**MINUTES OF
60th MEETING OF EXPERT GROUP ON ZOO DESIGNING
OF CENTRAL ZOO AUTHORITY
HELD ON 1st MAY, 2015**

DESIGN FOR THE CONSTRUCTION OF JACKAL ENCLOSURE, AT PIPLI ZOO,
DISTT. : KURUKSHETRA.

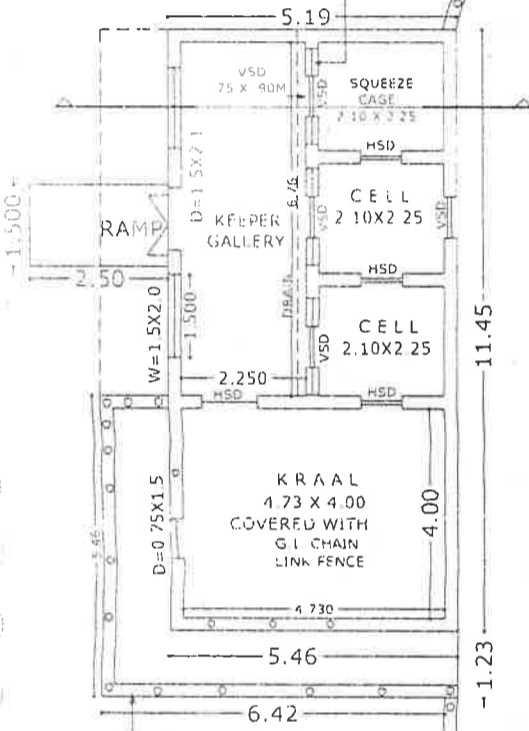
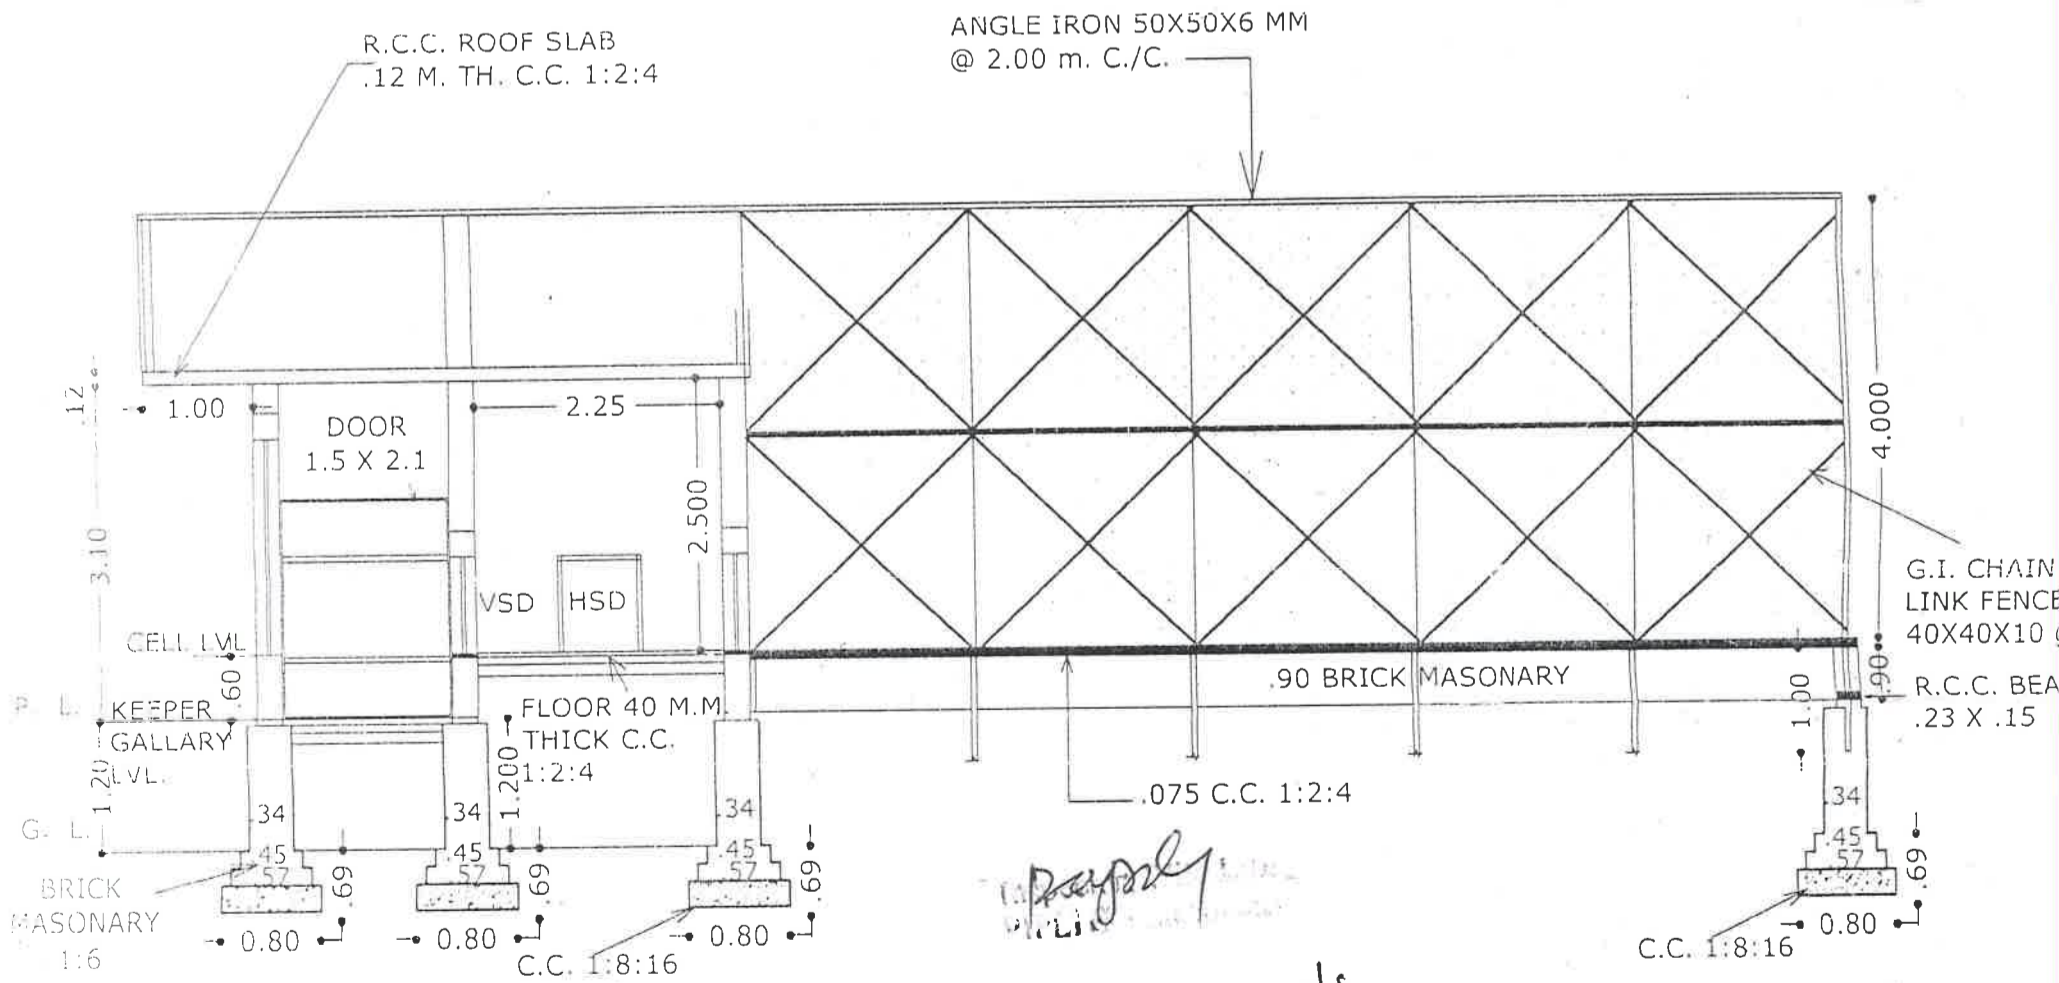
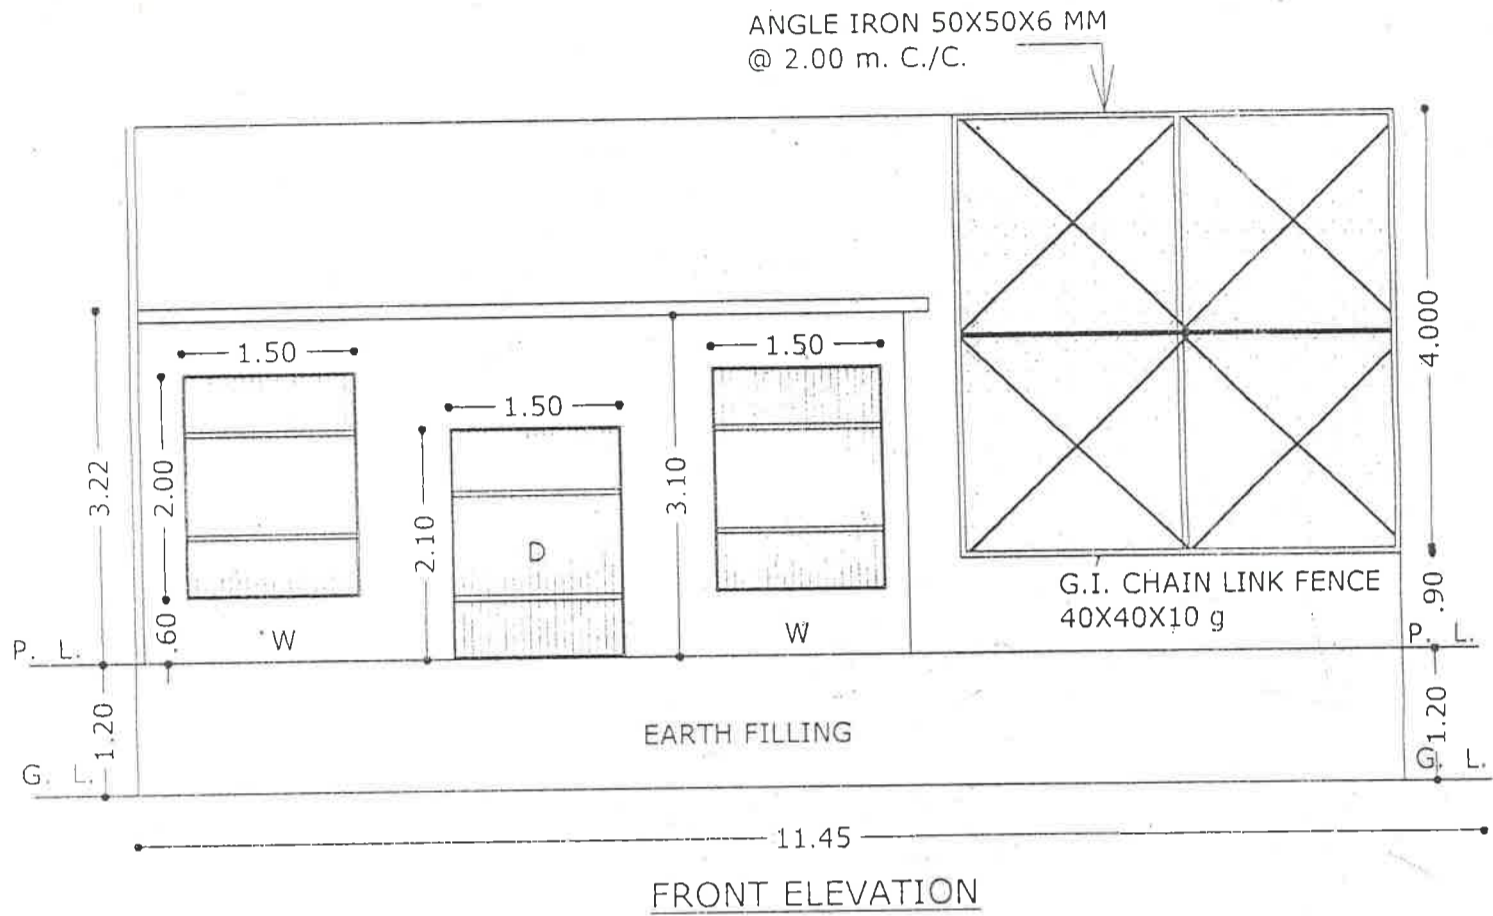
Members scrutinized the designs of proposed exhibit for Jackal and approved the same.
